Master Plan Amendment #2020-00001
Zoning Text Amendment #2020-00004
CDD Concept Plan #2020-00001
Development Special Use Permit #2020-00003
Potomac Yard Landbay H West - Silverstone
2602 Main Line Boulevard

Application	General Data	
Project Name: Potomac Yard Landbay H- West Silverstone	PC Hearing:	June 2, 2020
	CC Hearing:	June 20, 2020
	If approved, DSP Expiration:	June 20, 2023 (three years)
	Plan Acreage:	87,810 SF (2.01 acres)
Location: 2602 Main Line Boulevard (2600 & 2606 Main Line Boulevard)	Zone:	CDD #10 / Coordinated Development District #10
	Proposed Use:	Continuum of Care Facility (Independent Living, Assisted Living, Memory Care and Retail – Building 1; Independent Living – Building 2)
	Dwelling Units:	190 units
	Net Floor Area:	184,032 SF (Building 1) + 149,962 SF (Building 2) = 333,994 SF total
	Small Area Plan:	Potomac Yard/Potomac Greens
Applicant: Silverstone Alexandria, LP represented by M. Catharine Puskar, attorney	Historic District:	Not applicable
	Green Building:	LEED Silver or equivalent
Purpose of Application		
The applicant requests approval of a Master Plan Amendment, a Zoning Text Amendment, a CDD Concept Plan Amendment, and a Development Special Use Pe

Graphic A: Height-to-Setback Ratio Modification Exhibit

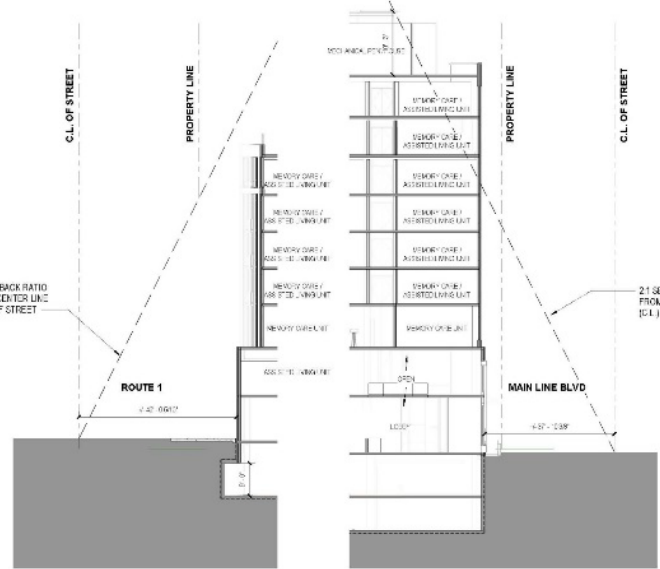
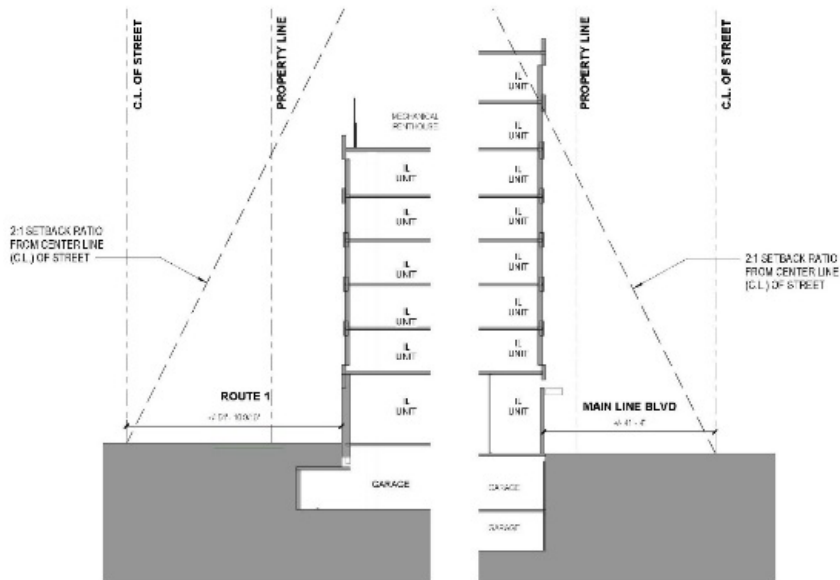
The height-to-setback requirement modification is requested in two instances for Building 1 (along Swann Avenue and Main Line Boulevard) and two instances for Building 2 (along Main Line Boulevard and Maskell Street). For Building 1, it represents about 16.5 feet of additional height compared to the setback provided along Swann Avenue and about 16.7 feet along Main Line Boulevard (or about 8.25 feet and 8.35 feet, respectively, of reduced setbacks compared to the heights provided).

For Building 2, it represents 13.2 feet of additional height compared to setback provided along Main Line Boulevard and 11.5 feet of additional height along Maskell Street (or about 6.6 feet and 5.75 feet, respectively, of reduced setbacks compared to the height provided). These types of modification are a result of the meandering nature and variable width of Main Line Boulevard coupled with the approved building heights per the Small Area Plan. The Small Area Plan anticipated taller buildings in this portion of Potomac Yard as blocks approached the Town Center in Landbay G and Landbay F (North Potomac Yard). Staff believes the modifications are desirable given that the proposed buildings are appropriately setback while supporting the continued streetwall consistent with the urban development pattern broadly recommended in the Small Area Plan and the Urban Design Guidelines and Standards.

Staff continues to support the request for site plan modifications regarding the height-to-setback requirements. Staff finds that the proposal continues to meet the three criteria for modifications pursuant listed in Section 11-416 as described below.

Graphic F: Building #1 – Revised SW Elevation per PYDAC Comments 10.5.2018

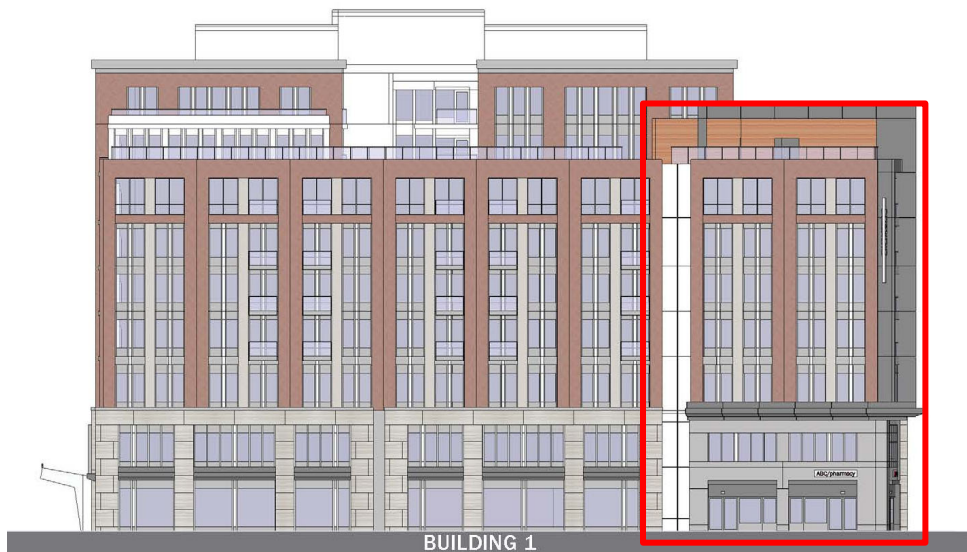
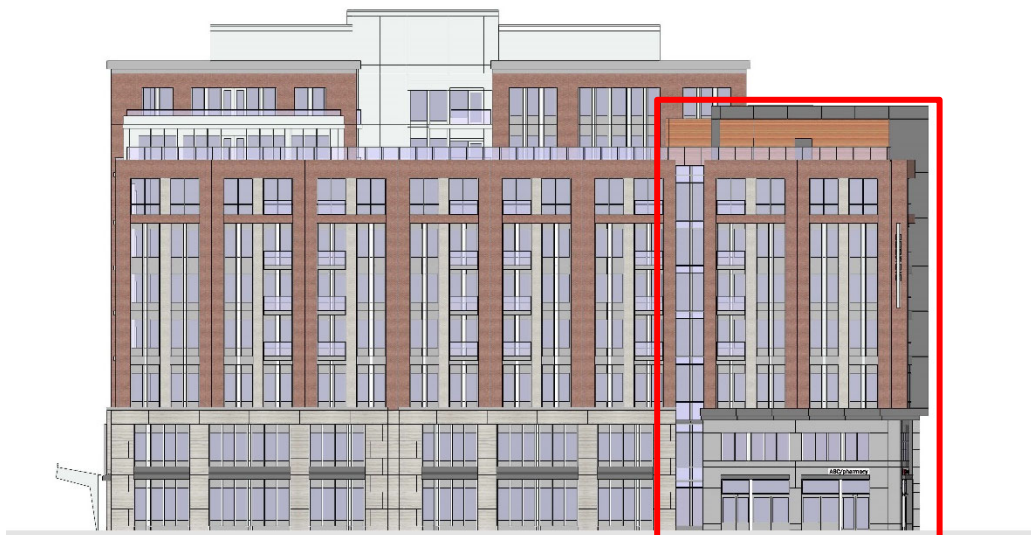
15. Comply with the following guidance for Building 1 (South building)
- a. The expressed seam on the west elevation shall be detailed such that the spandrels read as continuous with and as similar to the vision glass as possible as depicted in Graphic F. Continue to work with Staff to refine materials selection and details though the Final Site Plan.
